BUREAU OF AIR QUALITY
ENGINEERING REVIEW - SUMMARY (NOI Dated 4-13-83)
ENGINEER/DATE Dave Kopta/John Walton/8-26-83

Owner/Operator: Intermountain Power Association

Source: Intermountain Generating Station

Type of Operation: Coal Fired Boiler, Utility Electric Steam Generator

Figure 2, Oxygen vs NOx at full load.

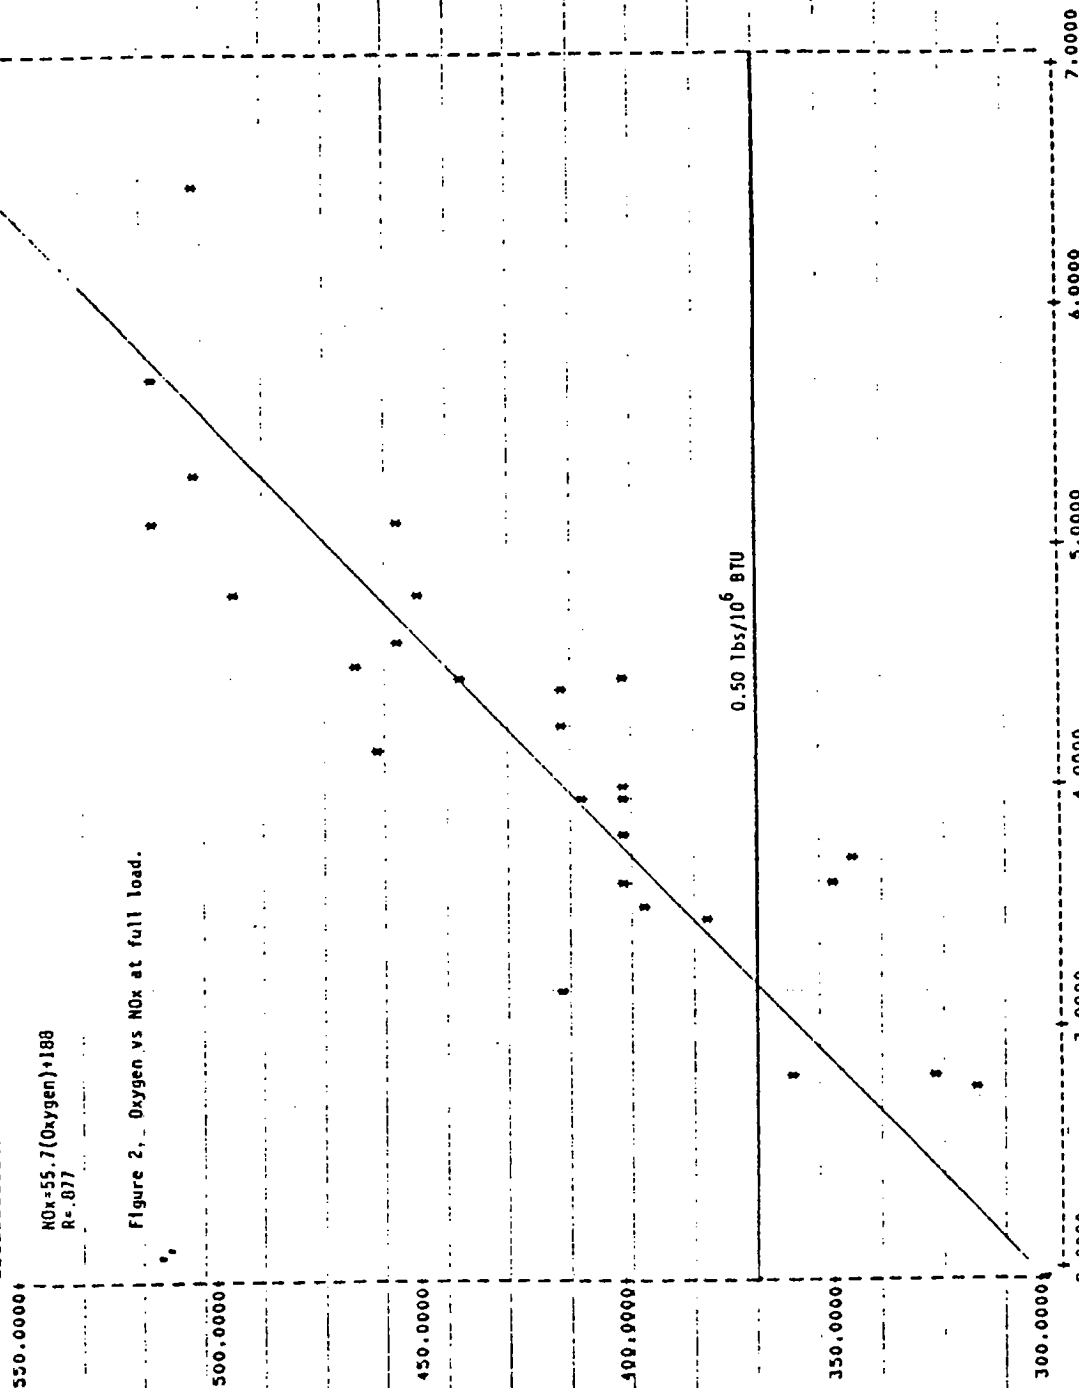
Figures 1 & 2 illustrate the data from the low NOx operational adjustments at Millcreek #3. Figure 1 demonstrates that the unit consistently operated below $0.50 \text{ lbs}/10^6 \text{ BTU}$ at low loads throughout the testing. Figure 2 illustrates the affect of excess oxygen on NOx emissions at full load. This correlation was obtained irrespective of other boiler parameters and clearly demonstrates the importance of excess oxygen on NOx emissions. The regression equation predicts that operation at 3.2% excess oxygen would achieve compliance with a $0.50 \text{ lbs}/10^6 \text{ BTU}$ NOx limitation under full load conditions.
